Re: Amendment Request to Process an Alternate Feed Material from the Linde FUSRAP Site
at the White Mesa Uranium Mill
Source Material License SUA-1358

Addendum 1

Tailings Capacity Evaluation

Proposal for Containment of Contaminated Materials in Cell 1-I

Figure III-1

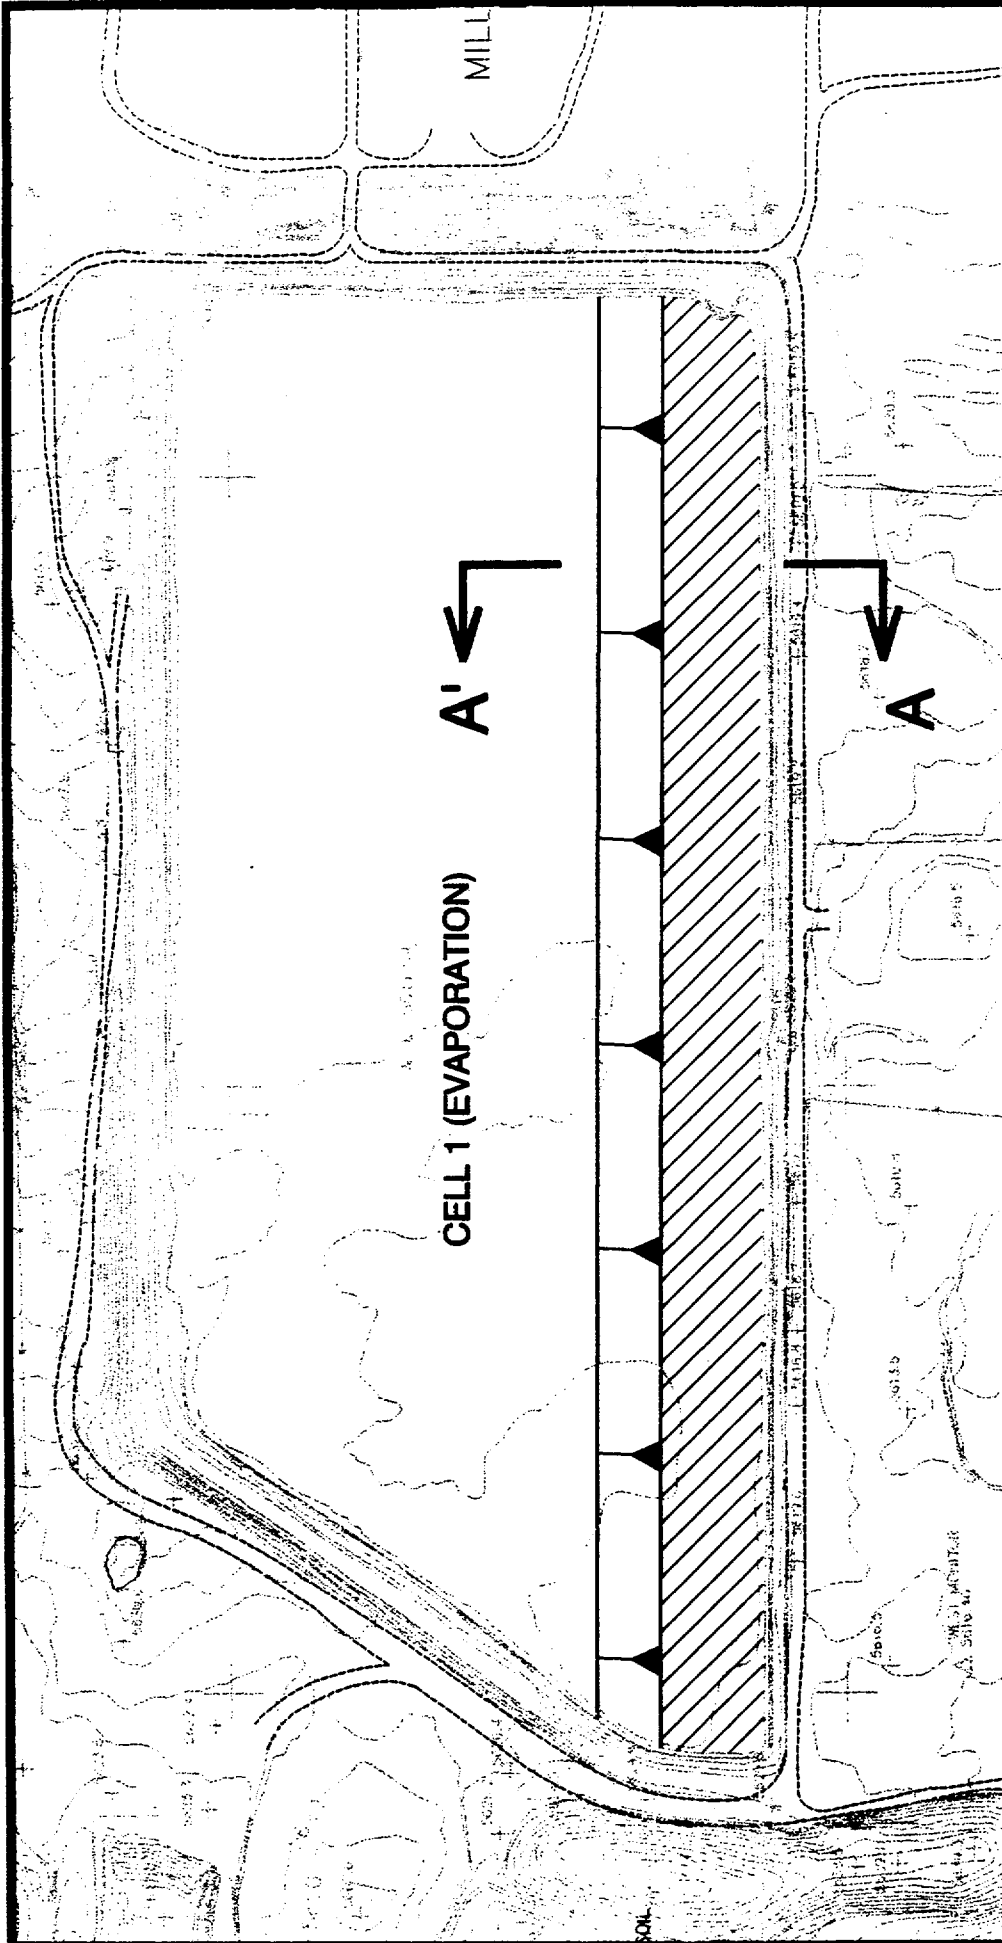
A proposed alternative for disposal of the remaining contaminated materials and debris from the Mill area reclamation would be to place the material along the upstream face of the dike between Cell 1-I and Cell 2, extending along the entire length of the dike. See the attached Figure III-1. The estimated volume of this material, 280,000 yd³, would cover an area approximately 175 feet wide along the 2,400 foot length of the dike. The total additional area would be approximately 10 acres. The width of the additional contaminated material would vary depending on the final volume of cleanup materials, and the concept would give the added advantage of having additional storage, if needed, in the remaining area of the Cell. The area containing the additional volume of contaminated materials in Cell 1-I will be lined with up to 18 inches of compacted clay, equal in quality to the material currently specified for use as the radon cap. The final design of the clay liner would be in accordance with regulations in effect at the time of final decommissioning of the mill.

The placement of material in the Cell 1-I area would be one of the final scheduled events in the decommissioning of the Mill. Depending on the actual volume of material processed through the Mill, a portion of the volume of material from the decommissioning and cleanup of the Mill site area may be needed for use in establishing the final grades and contours, prior to installation of the reclamation cap, in the Cell 2 and Cell 3 impoundments. The remaining volume will be placed into the proposed disposal area in the Cell 1-I impoundment. Clay material obtained from the Section 16 borrow area, specified as an alternative for use in the construction of the radon barrier for Cell 2 and Cell 3, will be used to construct the bottom liner of the Cell 1-I disposal area. Contaminated material from the Mill site decommissioning will then be placed in the Cell 1-I disposal area and the reclamation cap previously placed over Cell 2 will be extended over the additional area as detailed in the attached Figure III-1.

SECTION A-A'
(See Figure III-1)

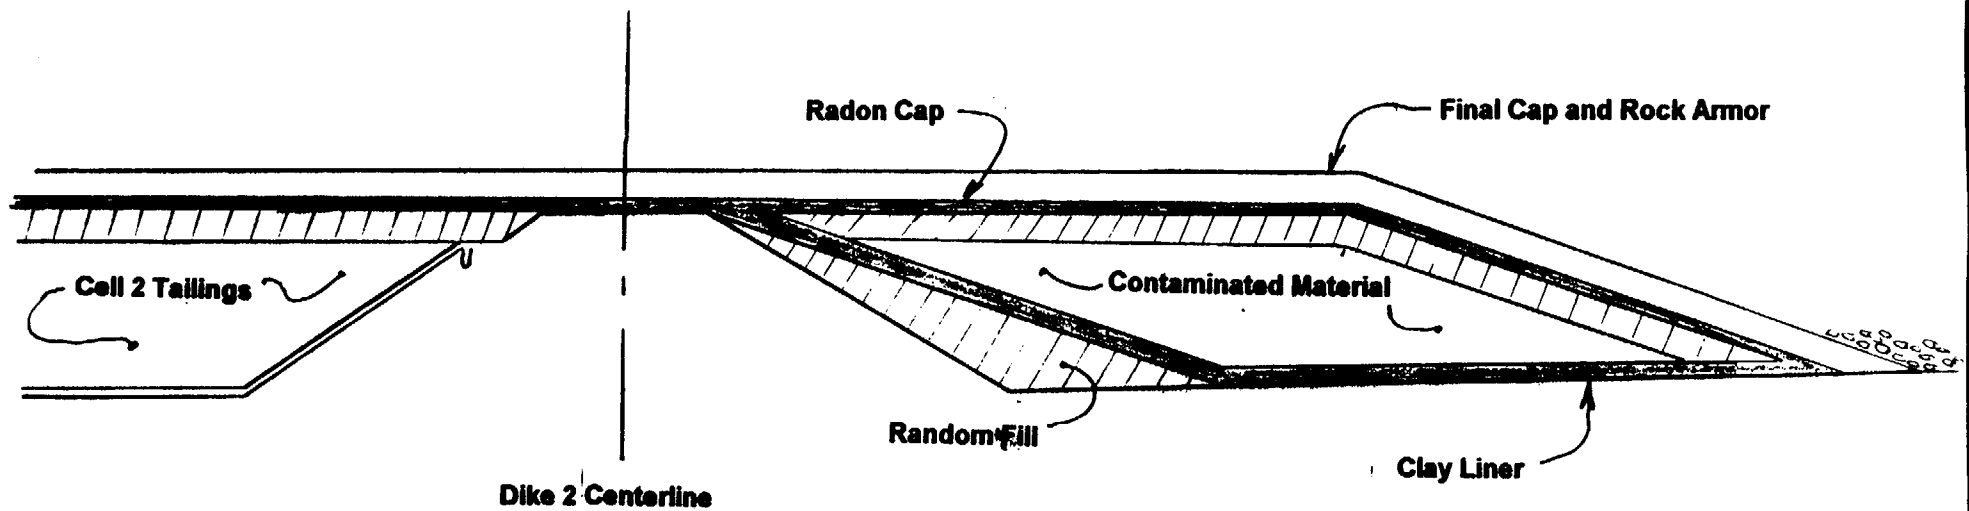
The material placed in the clay lined Cell 1-I area will be relatively dry (estimated to be less than 10% moisture content) and quickly covered with the engineered tailings area cap. The cap, including random fill, clay cap and rock armor would extend from the Cell 2 area as a continuous layer over the additional material. The cap will extend down the 5:1 slope on the upstream face of the extended disposal area, and tie into the clay bottom liner to create a full containment envelope around the contaminated materials. This will prevent any natural precipitation from moving through the material, and in conjunction with the bottom liner will eliminate the potential for migration of contaminants from this area.
